Report pursuant to s 42A Resource Management Act 1991

A Notice of Requirement to construct, operate, use, maintain and improve approximately 11.5km of new State highway connection between Ashhurst and Woodville

Section 42A Technical Evidence Addendum: Ecology

By: James Lambie, 4 April 2019

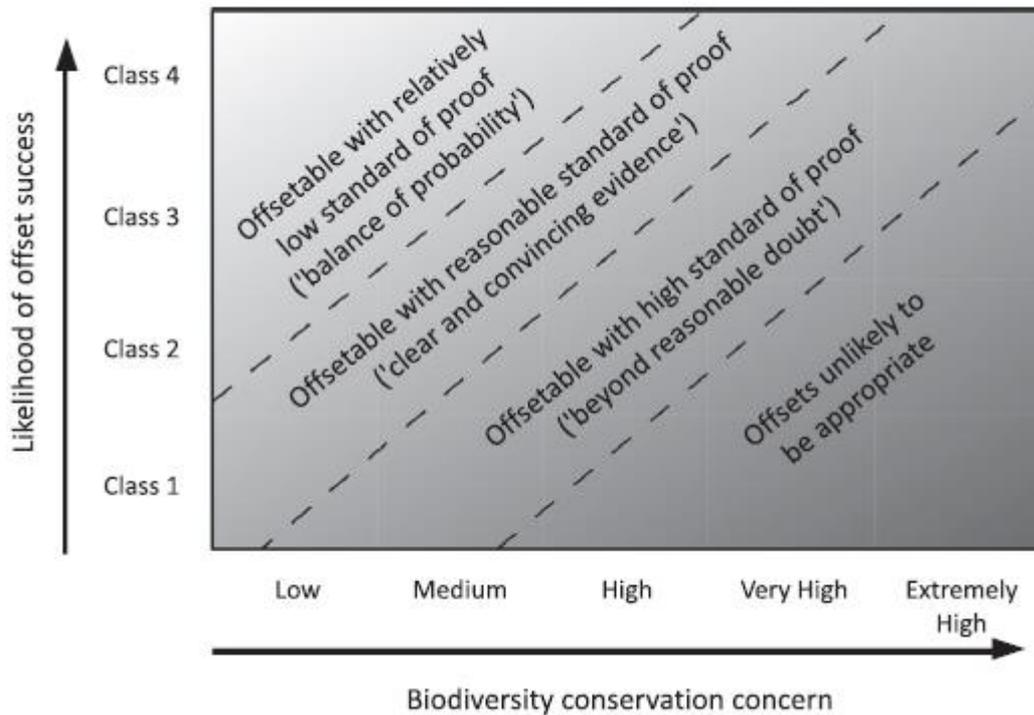
13. The level of biodiversity conservation concern (x-axis) for the “old growth” forests and indigenous seepage wetlands sit on the high to extremely high spectrum (see Dr Forbes technical report, at page. 61).
14. The Hearing Panel is aware that the land for placing offset plantings has not been secured, which at this stage reduces certainty of success. With a lack of certainty as to where sites will be located, there are also difficulties in testing the ecological equivalency of the proposed offsets. Therefore, the likelihood of success (y-axis) is, in my opinion, sitting somewhere around class 1 or class 2.

15. To my mind, failing a test of “beyond reasonable doubt” puts NZTA in a place where it should again be exploring options to avoid any of the habitats of high to extremely high biodiversity conservation concern. At the very least further work is required around the certainty of delivery of net biodiversity gain. In these circumstances the NOR corridor should provide for avoidance. This is the intent of Policy 13-4 of the One Plan, in my opinion, where a decision to use offsetting sits in an iterative cycle of avoid, then remedy/mitigate, and then offset residual effects, until it can be demonstrated that any offsetting would result in net gain (Paragraph 34 of my evidence).
